Minor Amendment to previously approved Administrative Amendment (SI-2022-01580). Modifications include addition of an Order Point and Meal Delivery Canopy (2 total), rerouting of a portion of the sanitary service and minor stripping modifications within the Property.

Reference: Chick-fil-A FSU #03235 Central & Eubank
210 Eubank Boulevard SE
Albuquerque, NM 87123
Letter of Authorization

FILE #: SI-2022-01580

Deviations Requested- Staff Summary Tables

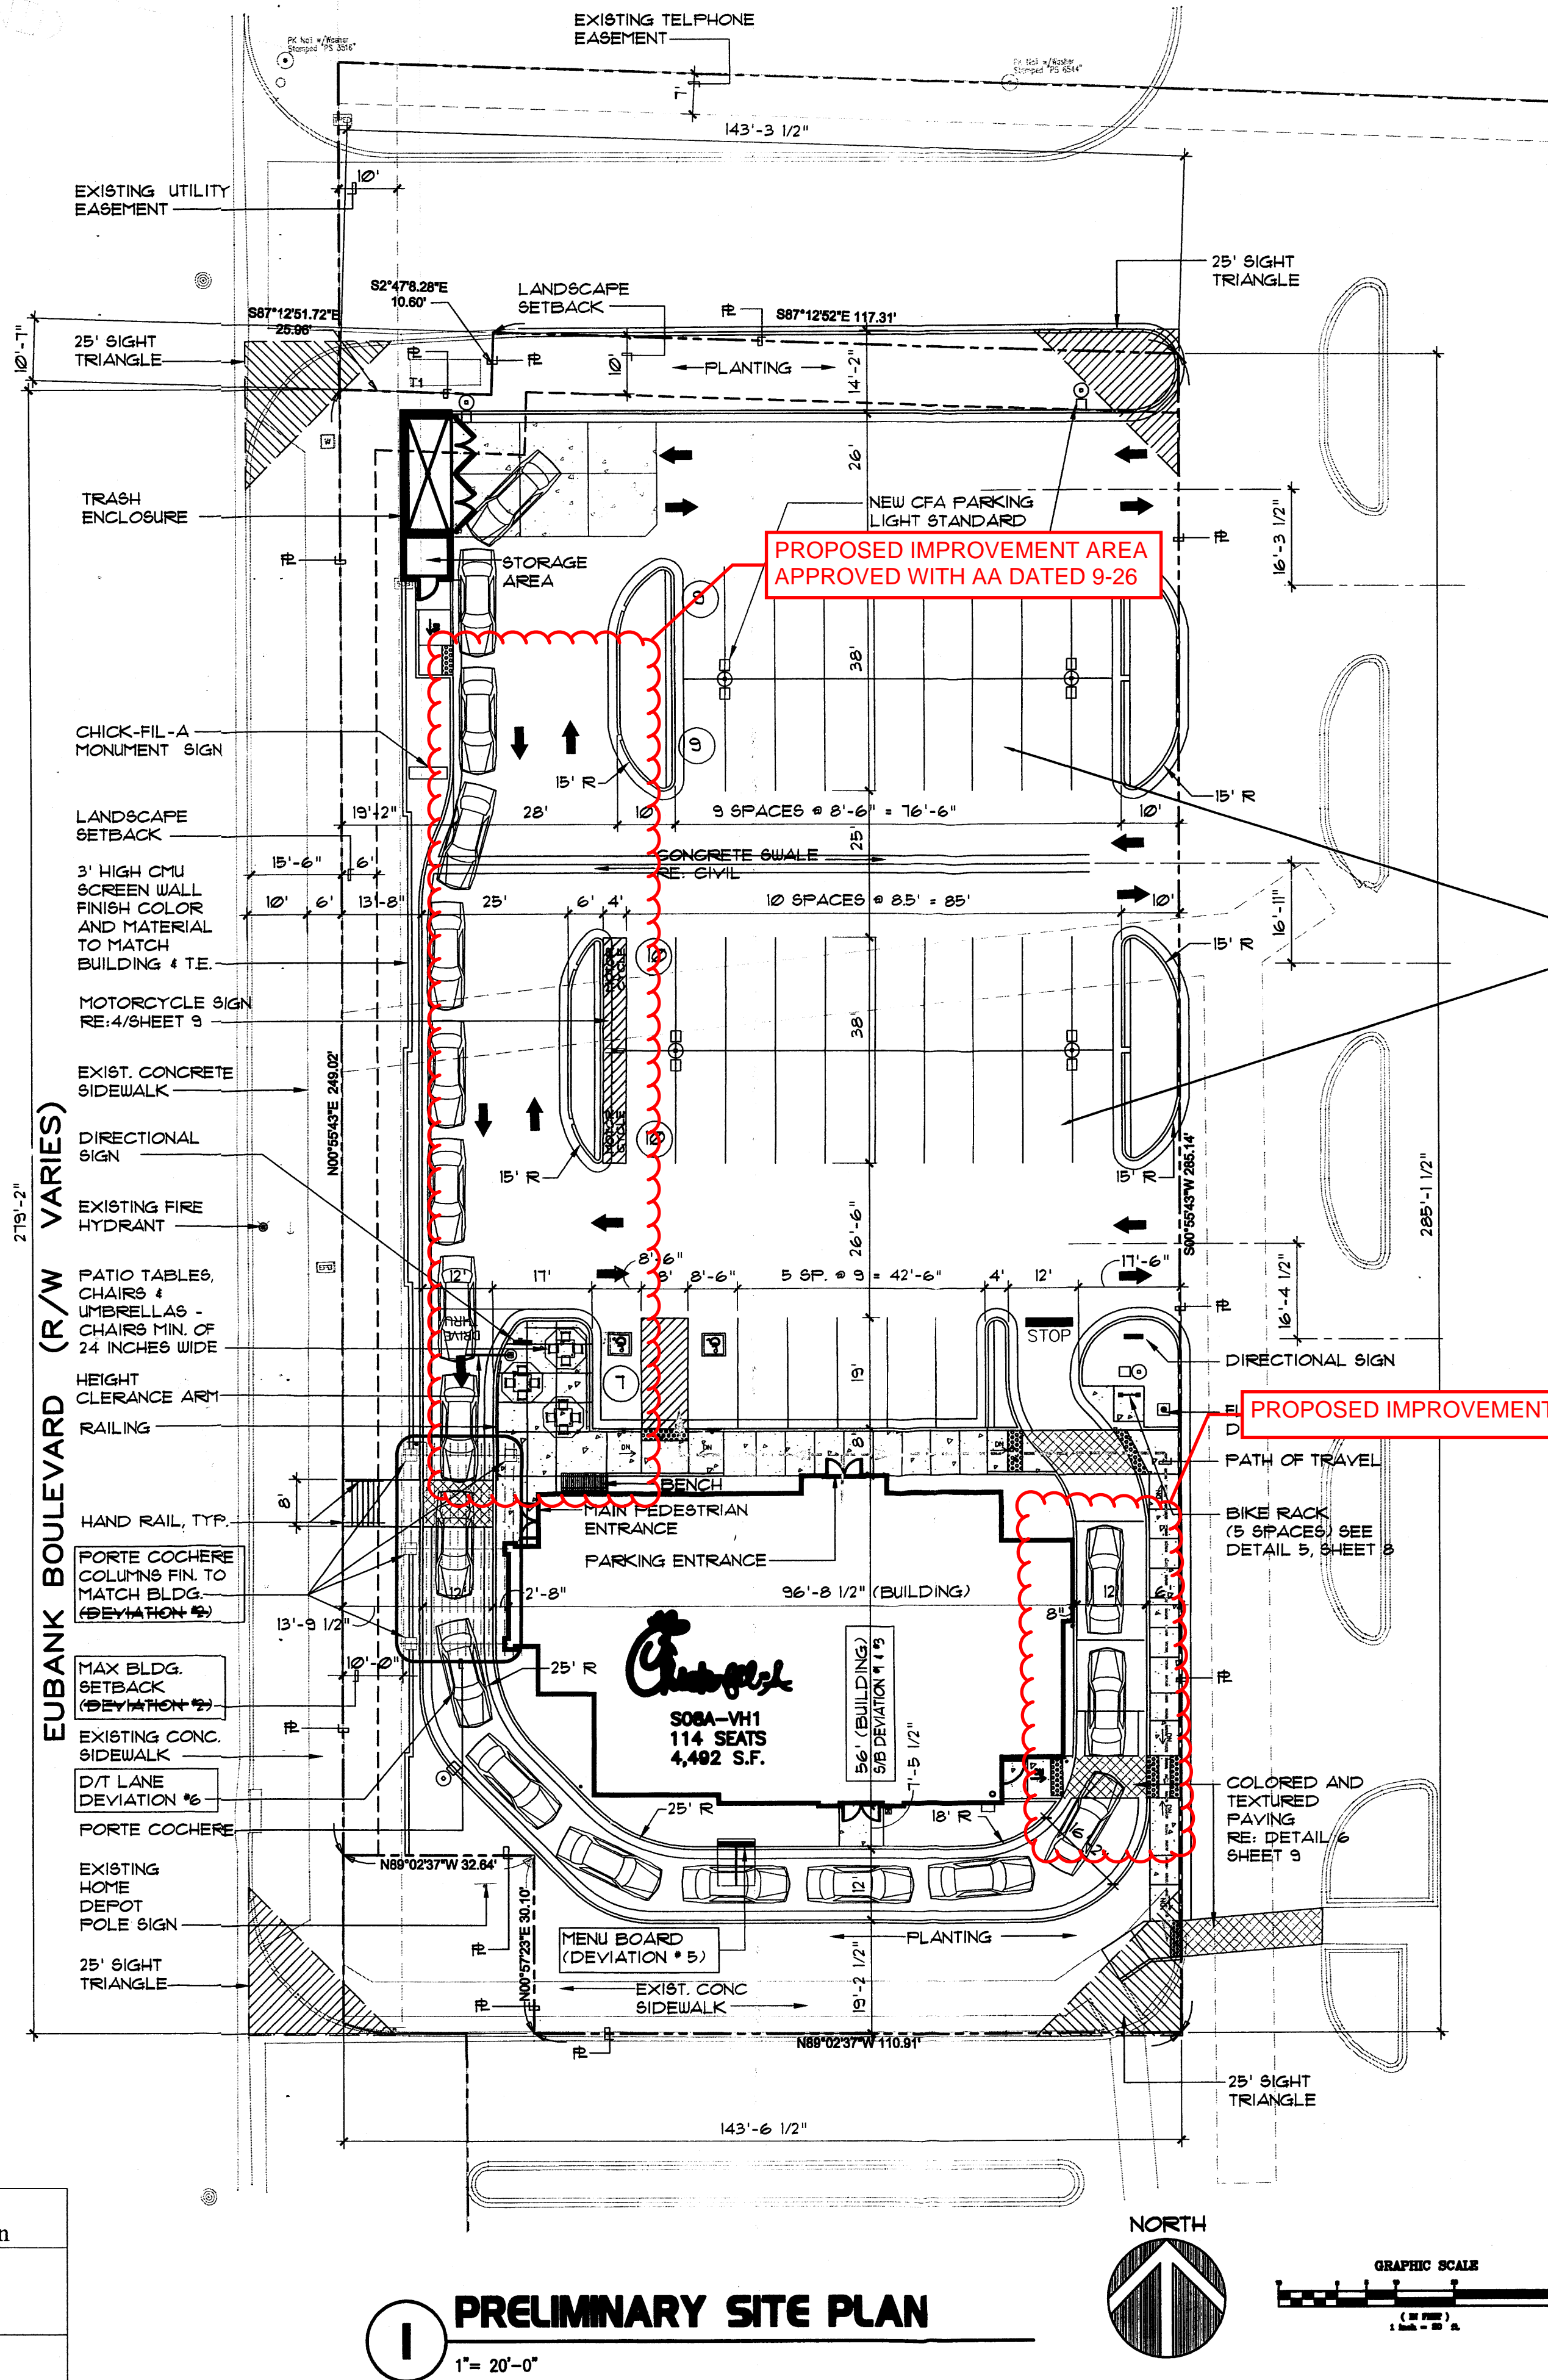
Revised application is for 5 deviations instead of 6 (#2 is addressed). Three deviations (#s 1, 3 & 4) are still major in scope. Two deviations are still to non-dimensional standards.

SHEET 1229-C-4.0_TRAFFIC CIRCULATION PLAN

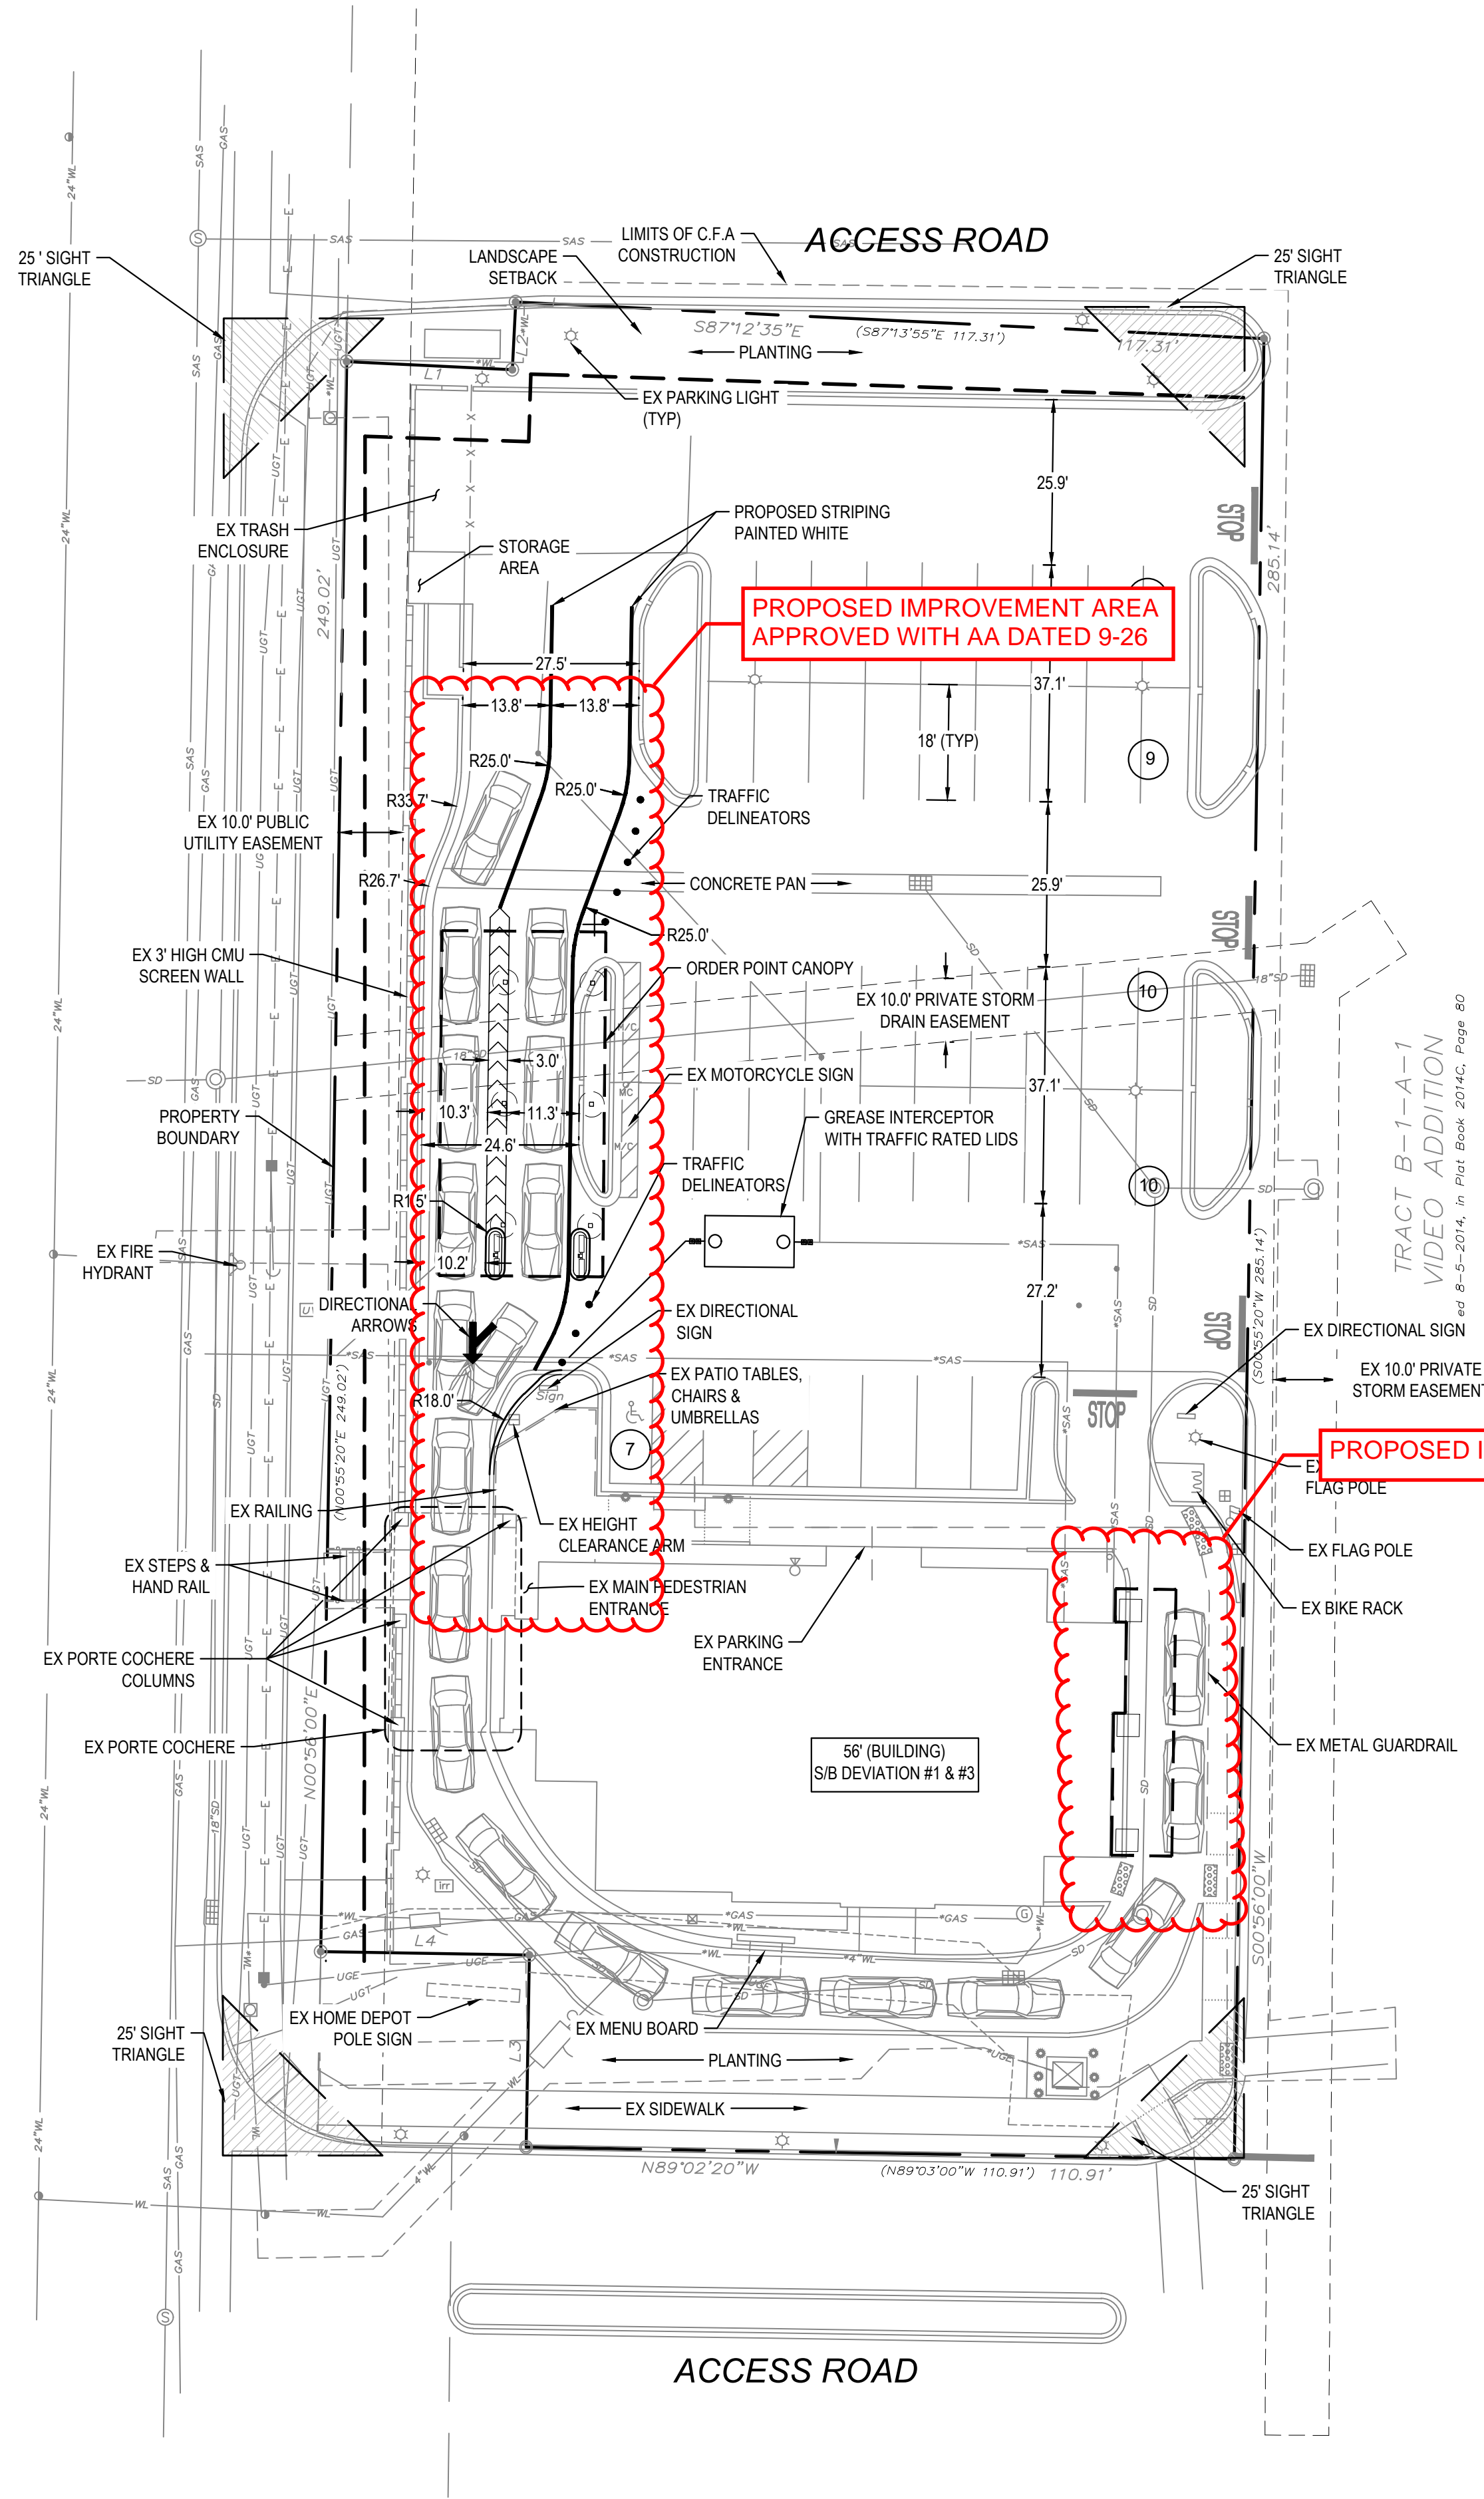
It is proposed to amend the prior Administrative Amendment (SI-2022-01580) to include the OMD Canopy at meal delivery window along the eastern side of the existing building. This Canopy was intended to be included with the prior AA but was inadvertently omitted. The OMD Canopy has a footprint of approximately 369 square feet and will stay within the limits of the existing drive thru lane.

THE PROJECT SITE IS LOCATED AT THE SOUTH-EAST CORNER OF CENTRAL AVE. & EUBANK BLVD. THE PROPOSED IMPROVEMENTS TO THE EXISTING CHICK-FIL-A SITE WILL INCREASE THE AMOUNT OF AVAILABLE STACKING WITHIN THE DRIVE THRU LANE. IN ADDITION, A CANOPY WILL BE INSTALLED OVER THE RELOCATED ORDER POINTS AND THE MEAL DELIVERY WINDOW AT THE EXISTING BUILDING. THE CANOPIES ARE BEING INSTALLED FOR TEAM MEMBER SAFETY, AND INCLUDE HEAT, FANS, AND LIGHTING. TRAFFIC FLOWS WITHIN THE PROJECT SITE WILL NOT BE SIGNIFICANTLY ALTERED AND THEREFORE THERE ARE NO FORESEEN IMPACTS TO THE ADJACENT USERS.
